RECOMMENDATION OF THE SOUTHWEST DESIGN REVIEW BOARD

Project Number: 3013307

Address: 3829 California Avenue SW

Date of Meeting: Thursday, April 11, 2013

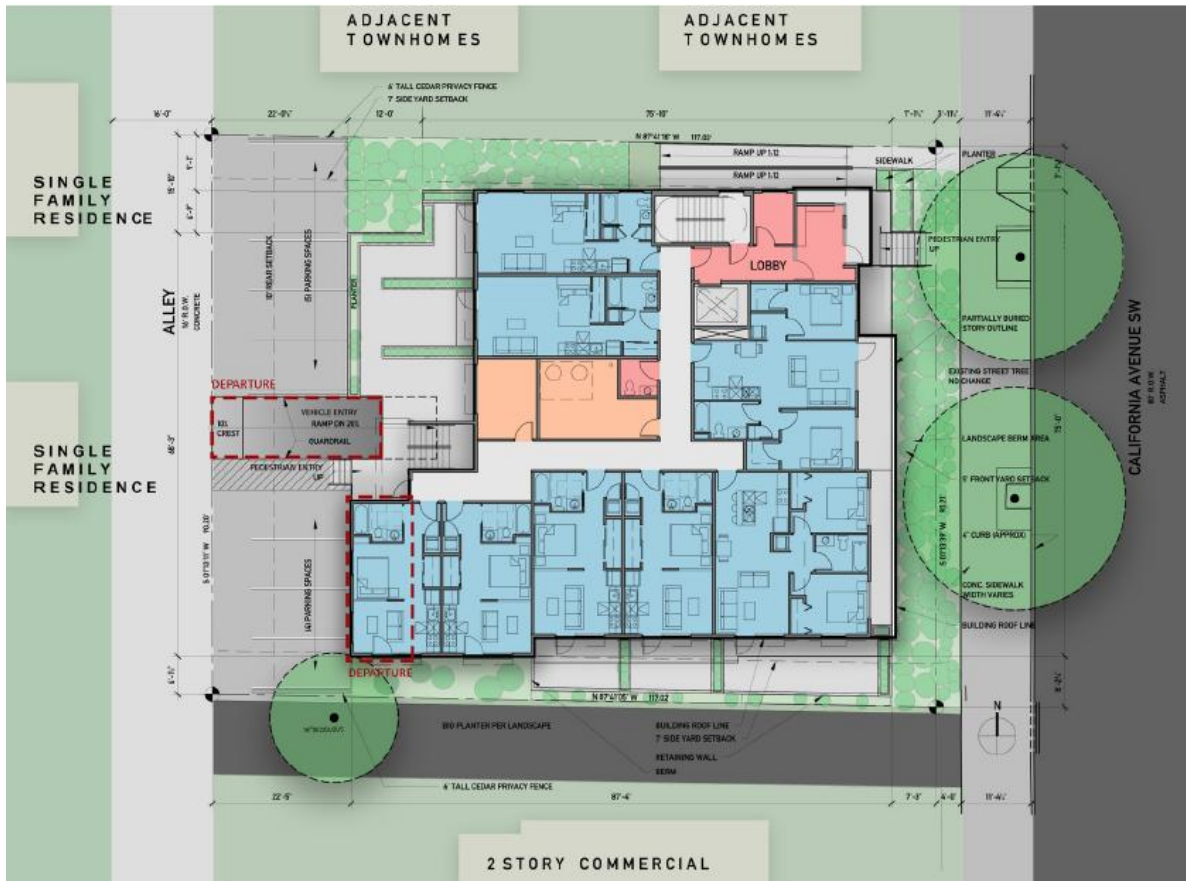
1. *Provide a better entry and entry sequence.* Seriously contemplate and study relocating the entry lobby to the northeast corner of the structure and lowering the lobby to align more favorably and commensurately with the front sidewalk. Symmetry was a hallmark of the structure on site that is being replaced. Not so of the newly proposed structure. The entry and lobby should be considered malleable features of the present edifice. Take advantage of an opportunity to provide more than just a perfunctory and prosaic “landing” and consider attaining or at least approaching a generosity of amplitude that would enable the dignity of an entry hall or more commodious lobby. Then work to successfully integrate the accessible ramp with the relocated lobby (clearly away from ground floor residential units). Make the entry and residential lobby and the pathway sequence by which to arrive there all clearly visible from the street.

2. *Improve the south façade and provide solutions to mitigate the Blank Walls.* Consider the south-facing façade a critical façade. Seriously consider pushing the wall away from the property line and adding some softening landscape elements between the property line and the wall; additionally, or alternatively, render the wall less of a wall.

3. *Push the building down.* Do this by pushing the garage structure down. Lower the overall impact of the parking structure by altering the floor to floor height of the garage, and seek creative solutions for dealing with the “Van stall.”
